Common-mode return loss limits

P802.3ck Draft 3.1 comments 48 and 49

Piers Dawe, Nvidia

Tx RLcc spec is ineffective above 7.25 GHz

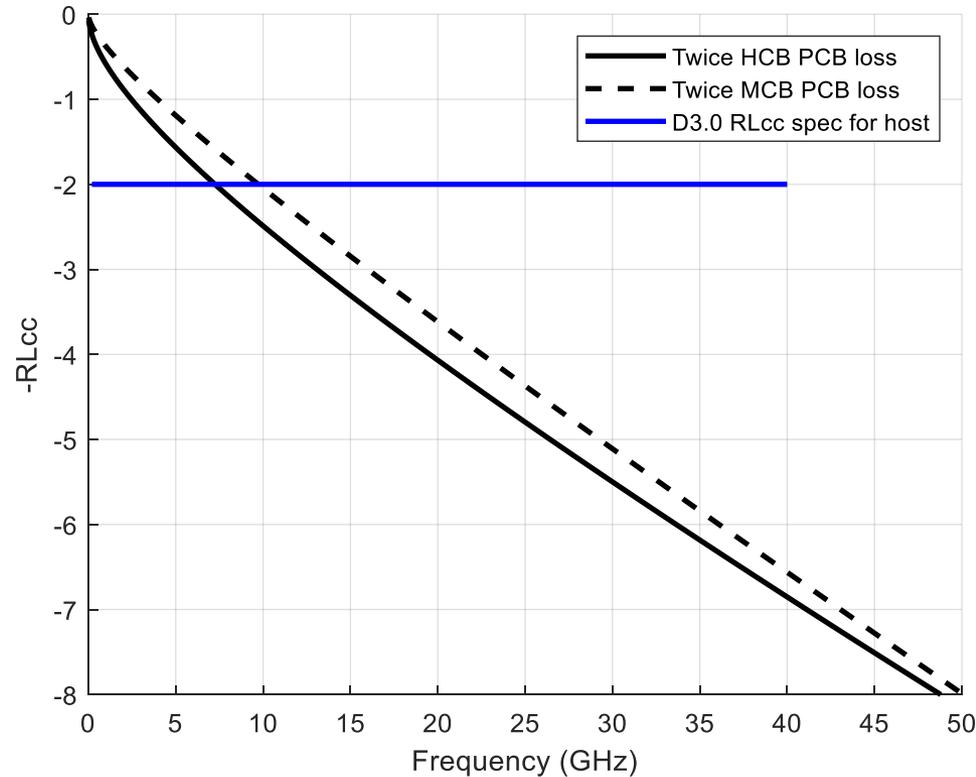
Comment 48 on CR Tx RLcc

- As already noted, this common mode return loss spec RLcc becomes useless at the frequency when the HCB loss is 2/2 dB, which is only 7.5 GHz. The spec should trend down somewhat slower than twice the MCB trace loss, at 0.1 dB/GHz
- Use a frequency-dependent mask
- 2 dB $0.2 \leq f \leq 4$
- $1.6 + 0.1 * f$ dB $4 < f \leq 30$
- $8.5 - 0.13f$ $30 < f \leq 40$
- f is in GHz
- See another comment for cable RLcc, 162.11.6.
- Same as D3.0 comment 178 (straw poll 9 to 10)

Proposed improved host RLcc spec

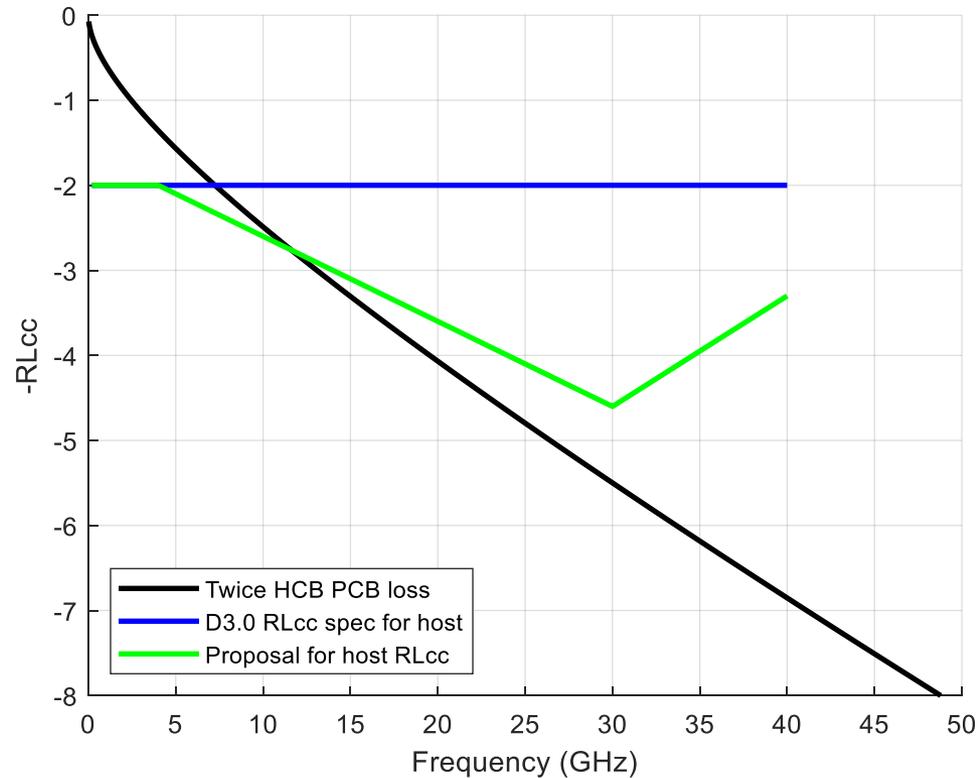
Comment 49

RLcc for cable is different to host

- At the lowest frequencies, the measurement can "see" connectors at both ends of the cable
- Spec in draft 3.1, 1.8 dB, is tight at low frequencies and ineffective from 8.5 GHz where the test fixture PCB loss is 1.8/2 dB
- The spec should be further relaxed at low frequencies, and tightened at higher frequencies
- 1.4 dB $0.05 \leq f \leq 6$
- $0.68 + 0.12f$ dB $6 < f \leq 30$ GHz
- $10.28 - 0.2f$ $30 < f \leq 40$
- f is in GHz

Illustrating the proposed RLcc spec

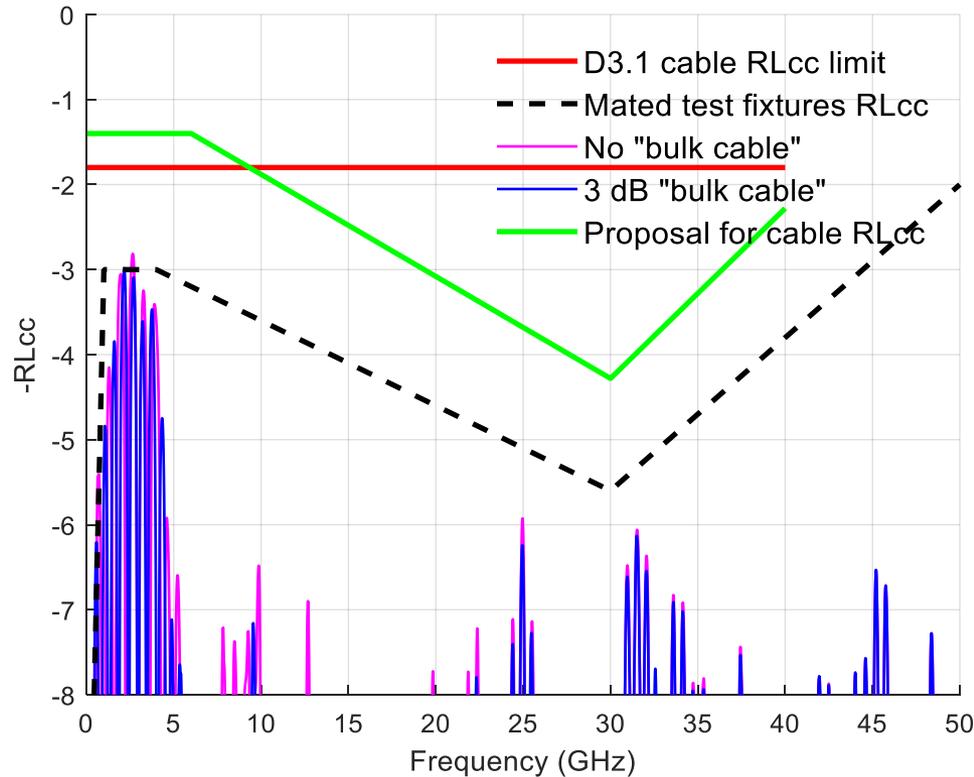
- Thin magenta: as on previous slide
- Thin blue: extra 3 dB lossy line between "cable" ends gives a small improvement at medium frequencies
- Green cable limit is well above both mated test fixtures limit and this measurement

Backup: D3.0 comment 181, earlier proposed RLcc spec for CR cable

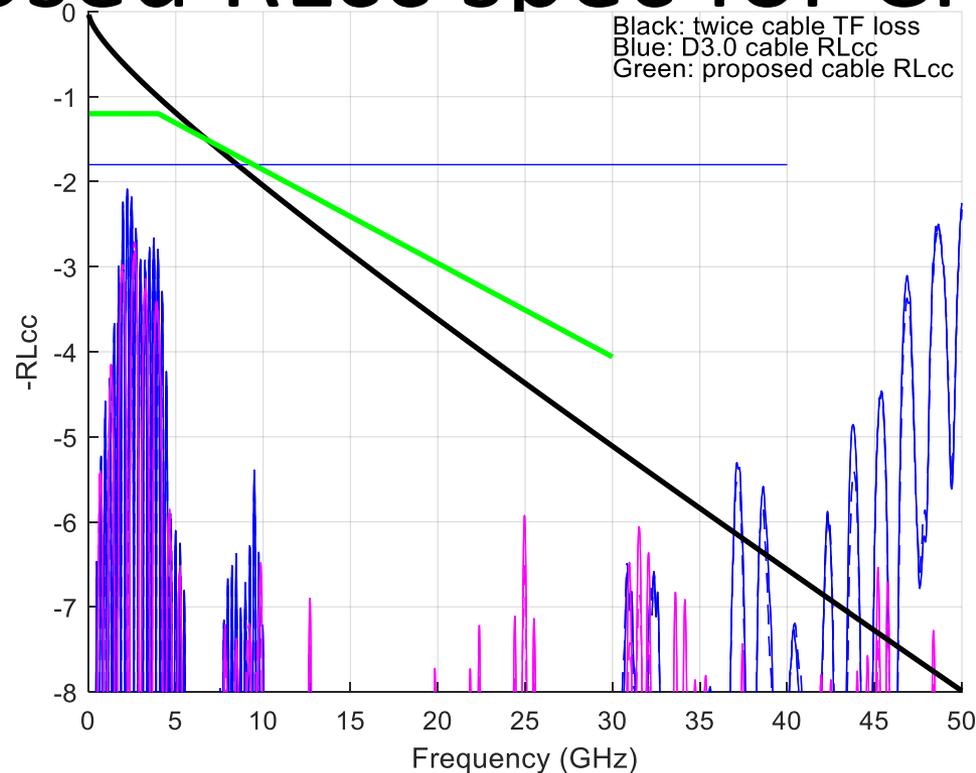
- 1.2 dB $0.05 \leq f \leq 4$
- $0.76 + 0.11f$ dB $4 < f \leq 30$ GHz
- f is in GHz
